# Office Action Summary

10/622,042

CHEN ET AL.

### **DETAILED ACTION**

a fore optic/window/substrate 150 having a first side proximate to said plurality of microlenses and having a second side. Figure 19 of Liu is reproduced below.

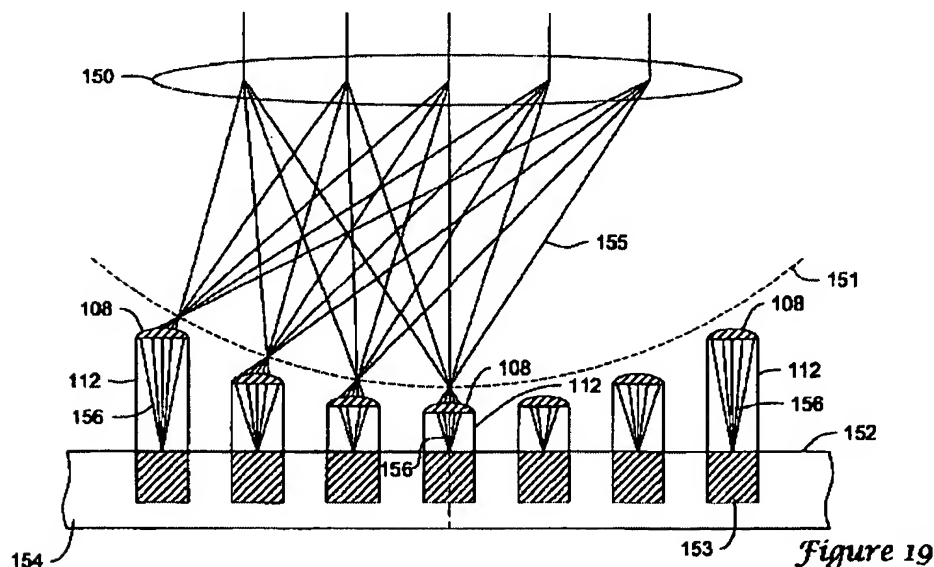
*In re* claims 1, 13, 27, and 37, Liu discloses an optical coupling system (e.g., Figures 19-20) comprising:

a substrate 154 having a plurality of optoelectronic elements 153 formed on said substrate;

a plurality of posts 112 formed over the plurality of optoelectronic elements 153 on said substrate wherein each post has a height of between about 30 microns and about 250 microns (see Fig. 11a; col. 12, lines 24-34; and col. 13, lines 8-10) ;

a plurality of microlenses 108 with each lens 108 formed on a first end of said posts 112, wherein the microlenses have a diameter of between 20 and 60 microns (col. 13, lines 8-10);

*In re* claim 2, the particular limitations are shown in Figure 19 of Liu.

Thus, Liu only differs from claims 1-4, 8-16, 18, 19, 22-24, 27-35, and 37-41, in that Liu does not mention that the fore optic/window/substrate 150 is made of glass. Liu does mention that the fore optic 150 may comprise a lens (column 1, lines 63-65). Glass lenses are well-known in the art. It would have been obviously expedient to use glass in the fore optic 150 of Liu in order to provide an operable lens. Therefore, it would have been obvious to one of ordinary skill in the art at the time of the claimed invention to obtain the invention specified by claims 1-4, 8-16, 18, 19, 22-24, 27-35, and 37-41 in view of Liu.
